**ADDENDUM NO. 1
MEADOWRIDGE BRANCH LIBRARY & MEADOWOOD
NEIGHBORHOOD CENTER REMODELING
CONTRACT NO. 7202**

ADDENDUM NO. 1

Re Meadowridge Branch Library &
Meadowood Neighborhood Center
Madison, Wisconsin
Engberg Anderson Project No. 132273.00

1 PARTIAL PLAN - PHASE 1
SCALE: 1/8" = 1'-0"

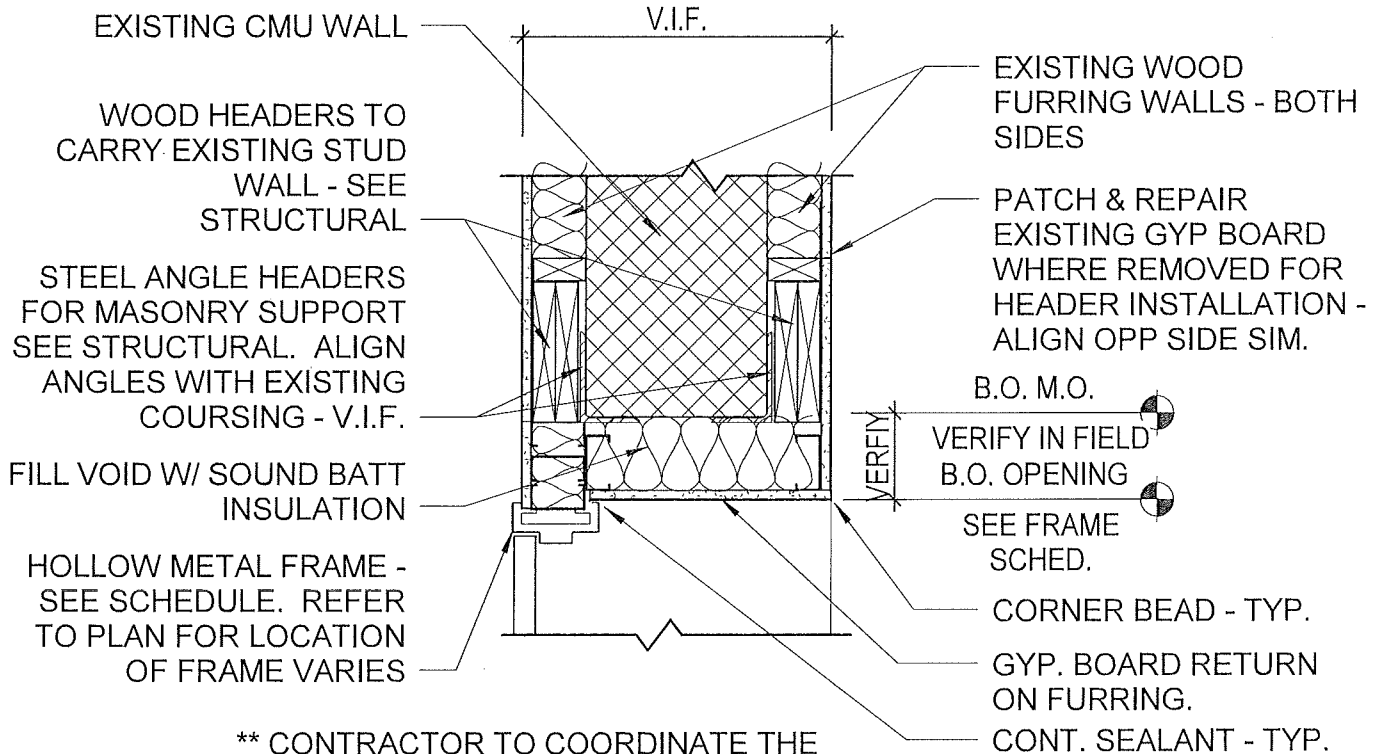
- On drawing 1/A101 a partial plan has been issued with changes to the door location that opens to the receiving room #308 that is to be constructed in phase 3 - see issued SD-01. The door location has been moved down to accommodate an added fire protection cabinet. The cabinet is to be installed in phase 1 and GC to coordinate schedule and work with tenant prior to construction.
- Add note to Keyed Notes - Phase 1: "Note #14" - see issued SD-01.

14. LOCATION FOR FIRE PROTECTION CABINET TO BE INSTALLED IN PHASE 1 COORDINATE INSTALLATION WITH TENANT.

FIRST FLOOR UNDERFLOOR PLUMBING NEW WORK PLAN

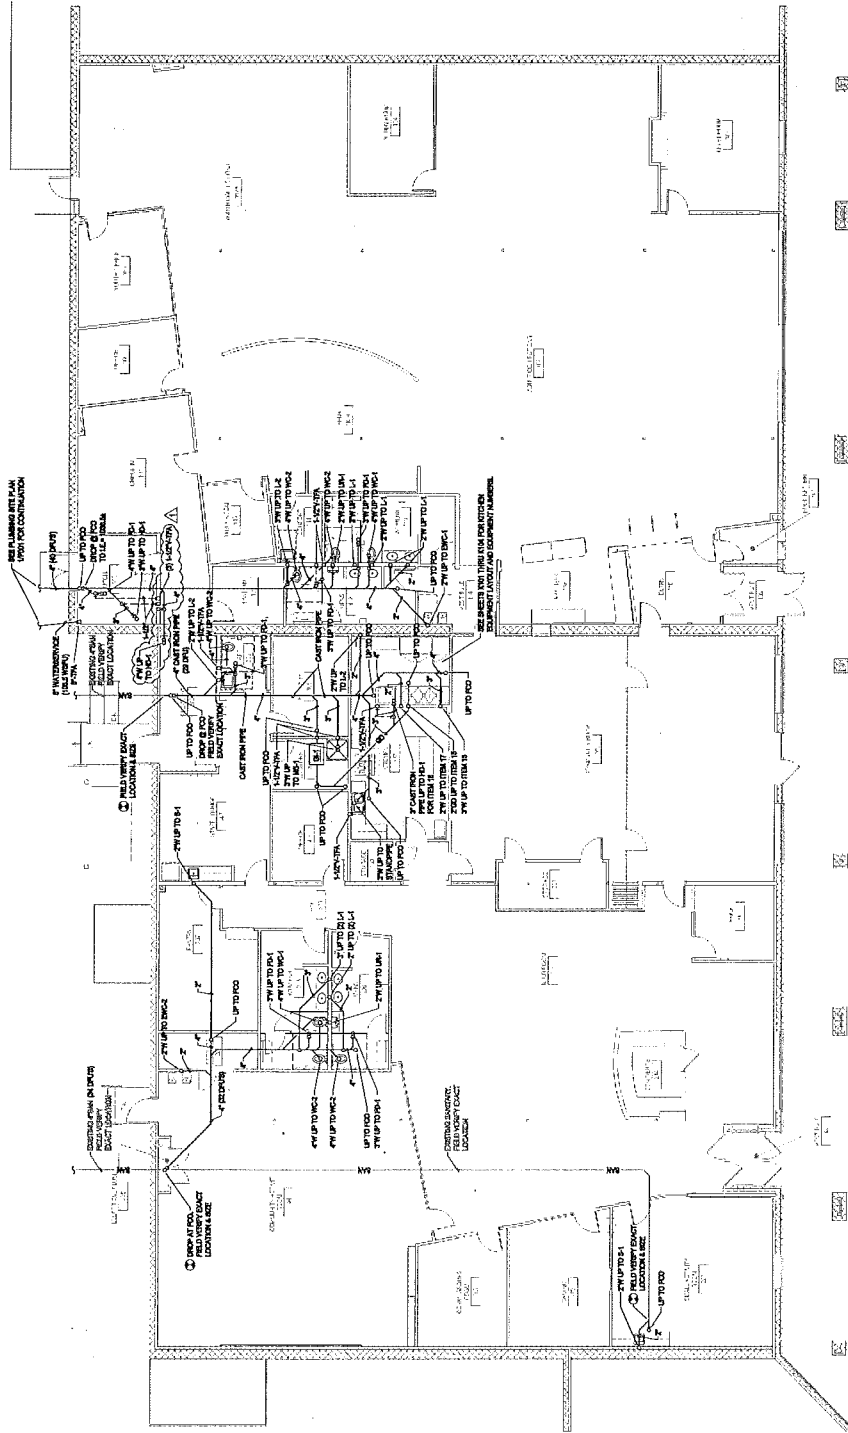
1. Add hub drain (HD-1) in room 308.
